# **A46 Newark Bypass**

**Scheme Number: TR010065**

## **7.43 Comments to Responses to ExQ1**

<b>Version</b>	<b>Date</b>	<b>Status of Version</b>
P01	November 2024	Deadline 3

Extract of the Nottinghamshire Minerals Local Plan

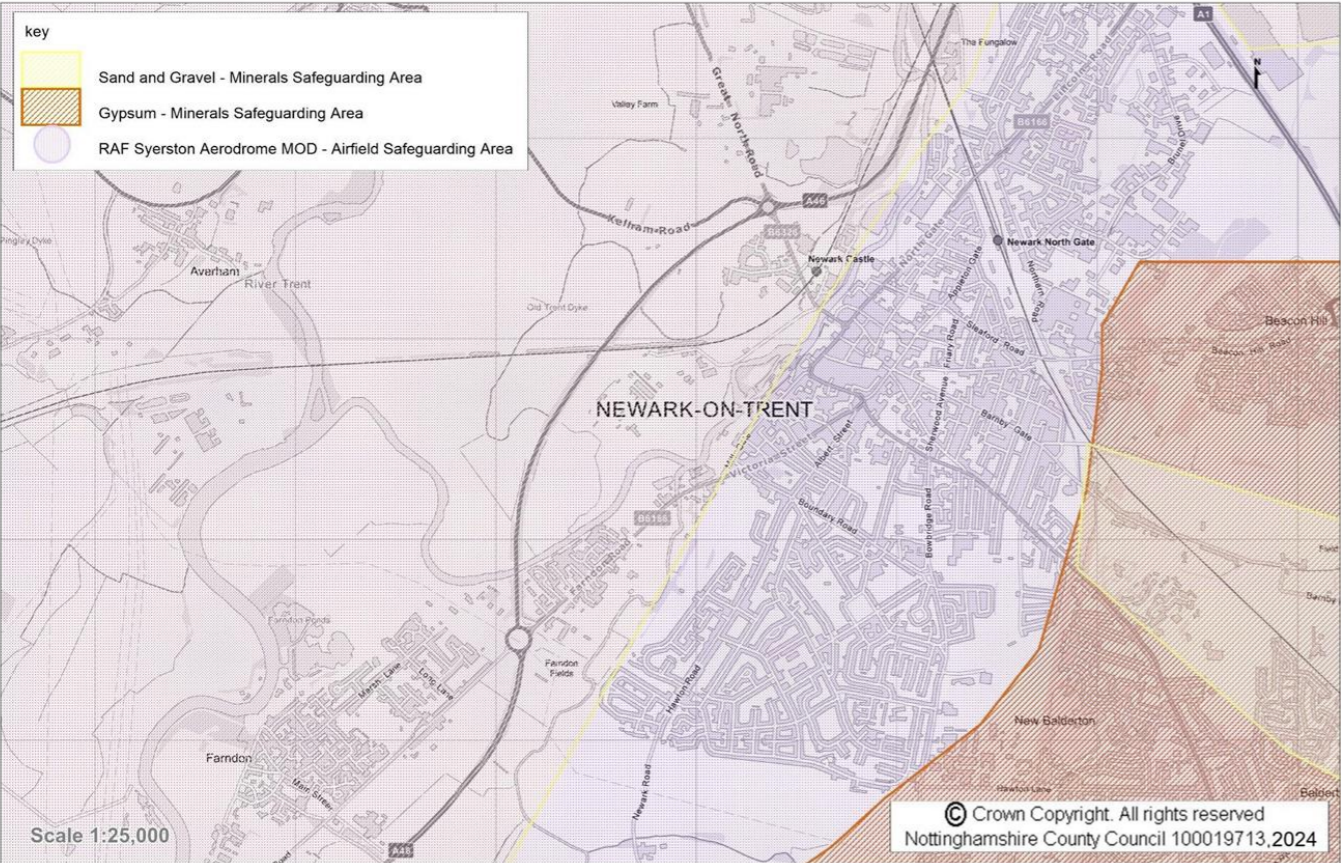
Q11.0.4	NCC	<p><b>Policy – Local</b></p> <p>a) Please provide a clear extract from the Nottinghamshire Minerals Local Plan (adopted March 2021) showing the area within which the Proposed Development would be located.</p> <p>b) Subject Area Plan C on page 160 of the Nottinghamshire Minerals Local Plan shows an area covered by yellow cross-hatching in a south-west to north-east direction. However, yellow cross-hatching in a south-west to north-east direction does not appear on the key. Please clarify.</p>	<p>a) Please find an extract of the Nottinghamshire Minerals Local Plan showing the proposed development area in Appendix A page 17.</p> <p>b) Unfortunately there is an error within the key for the mineral safeguarding and consultation area for sand and gravel, which should reflect the yellow cross-hatching in a south-west to north-east direction seen within Plan C. The County Council can confirm the yellow cross-hatching in Plan C is the mineral safeguarding and consultation area for sand and gravel.</p>	No response required
